SECTION 00 91 01

ADDENDUM NO. 1

BUILDINGS 5 & 6 RENOVATIONS
 San Mateo County Community College District

CAÑADA COLLEGE
 4200 Farm Hill Boulevard
 Redwood City, CA 94061

San Mateo County Community College District

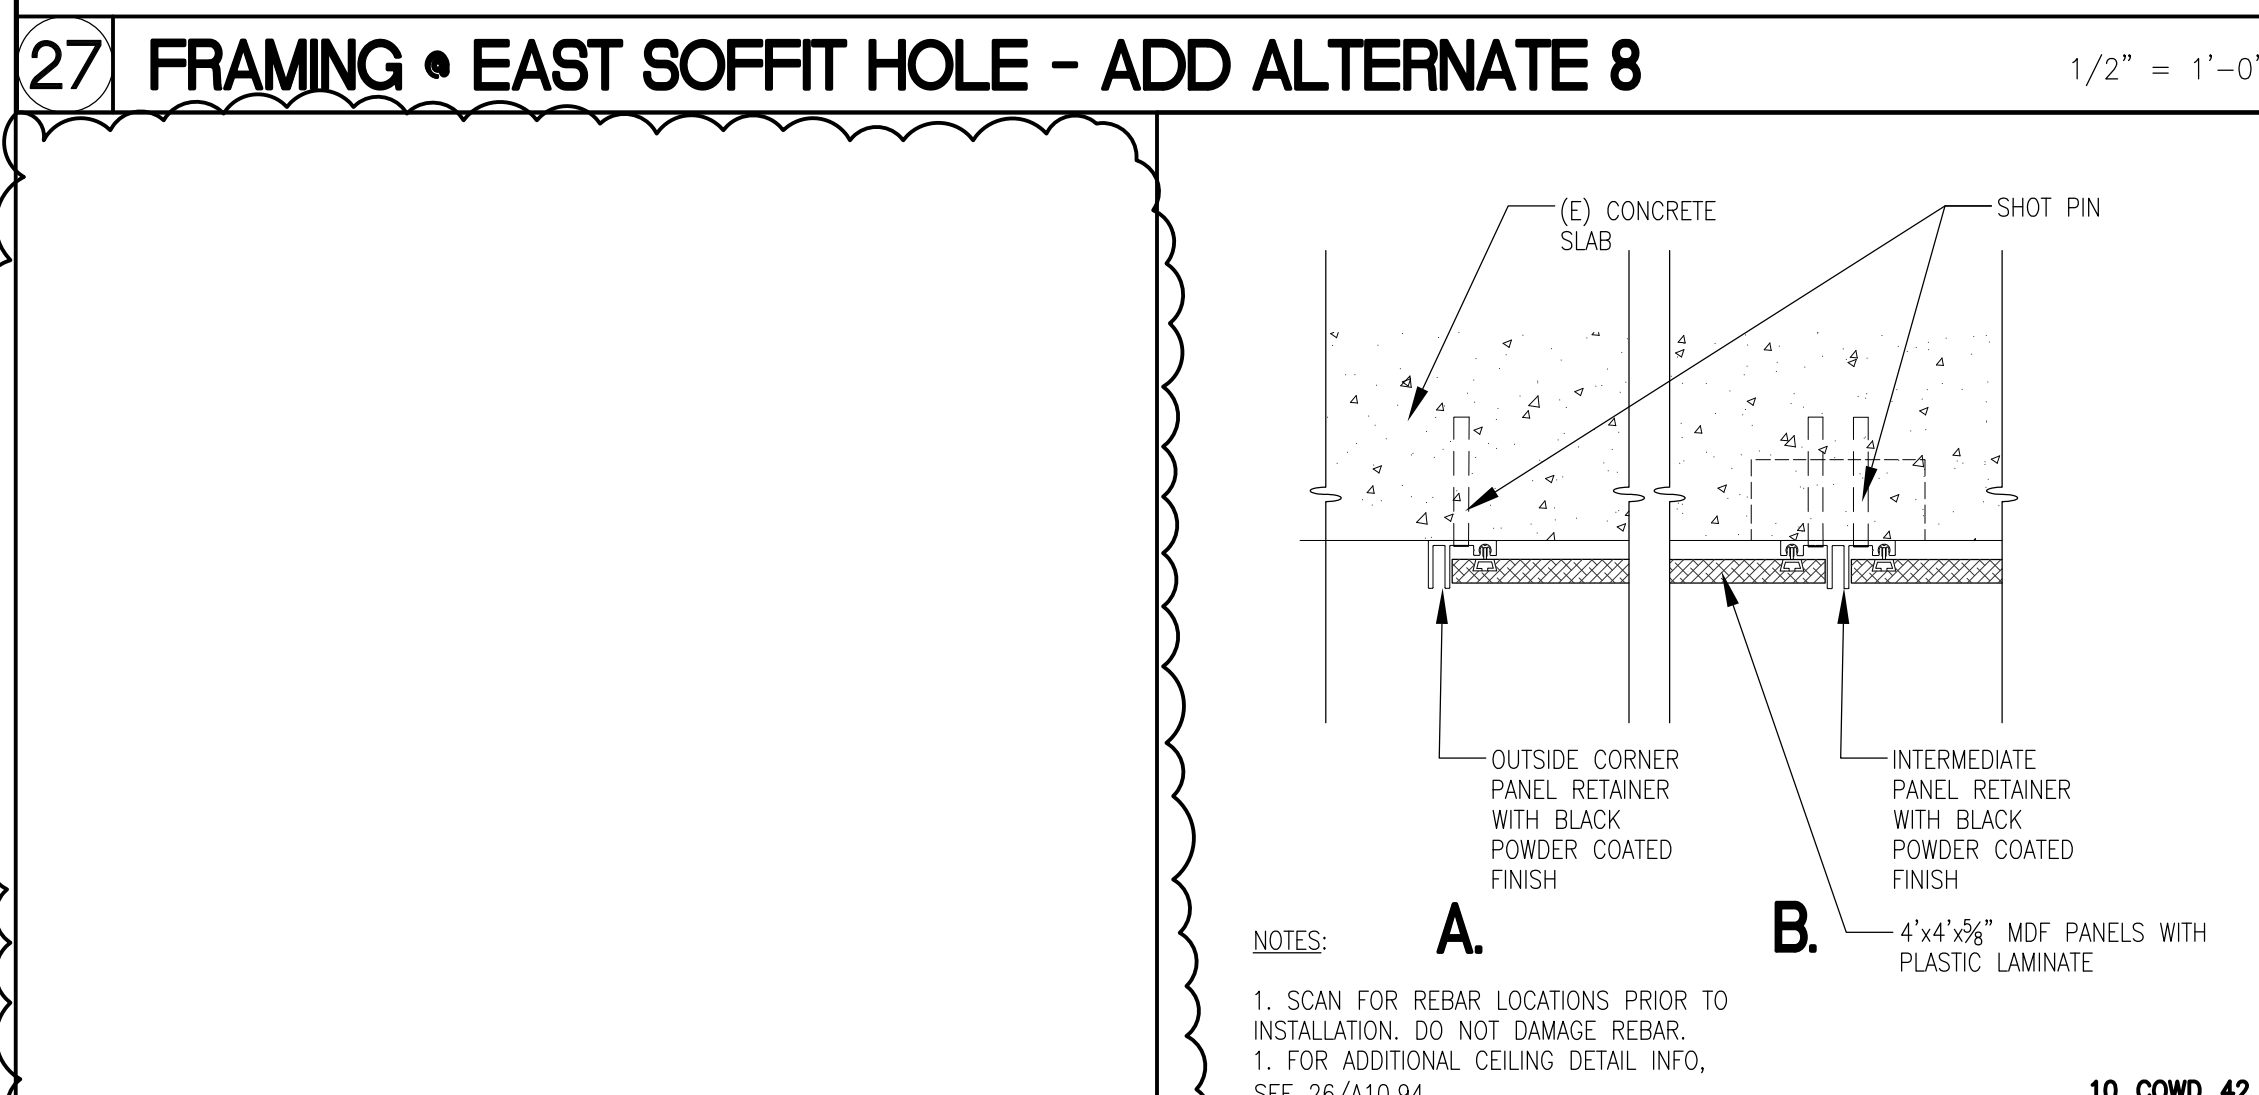
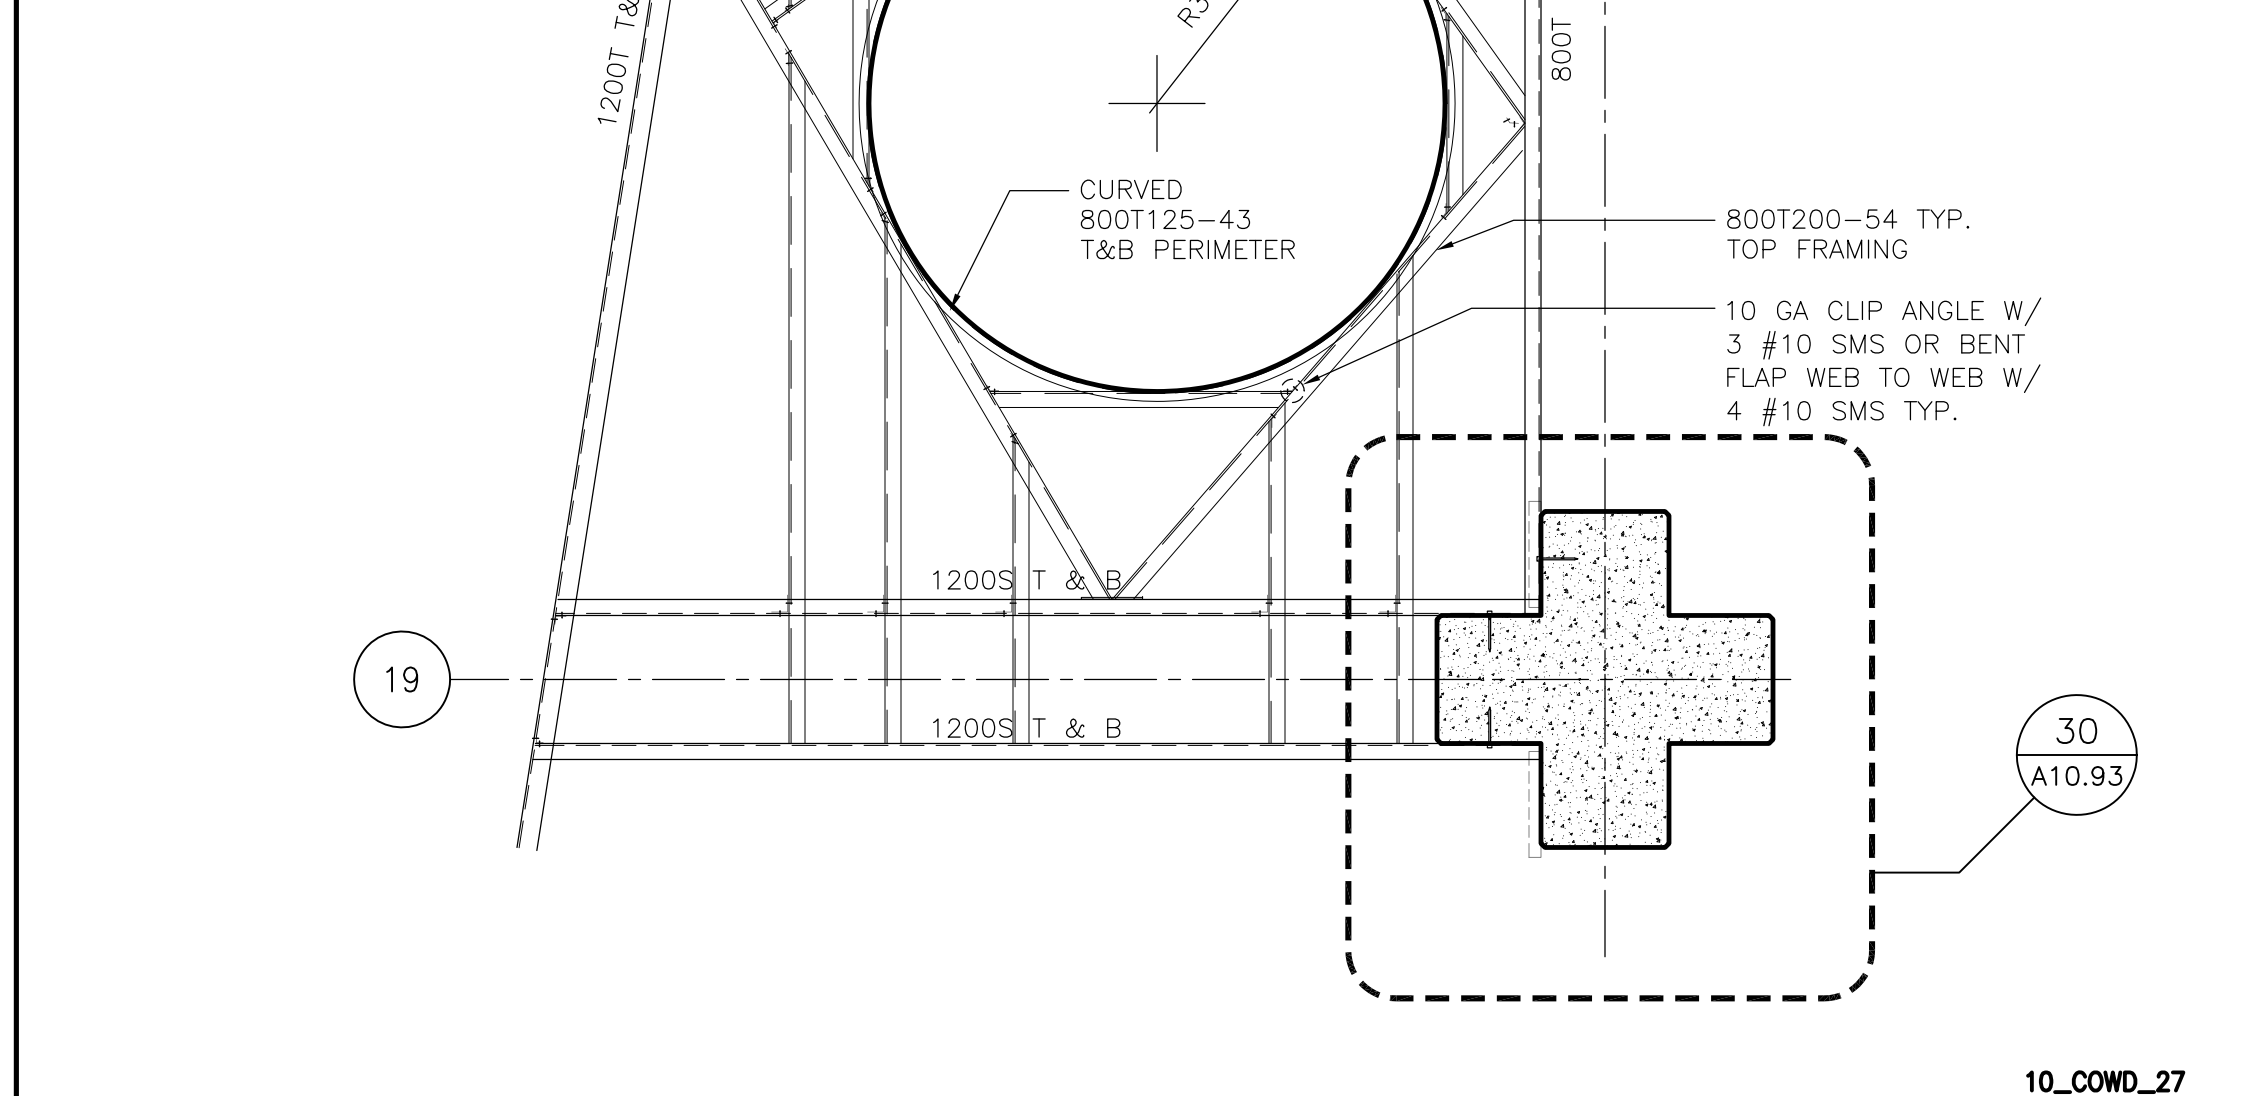
2. Revised Sheet Note 115.
8. Drawing A9.44R – Third Floor Finish and Signage Plan – Add Alternates.
 - A. Modified drawing as shown on attached revised Drawing A9.44R:

1. Revised Finish Legend and Third Floor Finish and Signage Plan.
 2. Revised Sheet Note 115.
9. Drawing A10.93R – Wall Types and Casework Details.
 - A. Deleted Detail 28, as shown on attached Drawing A10.93R.
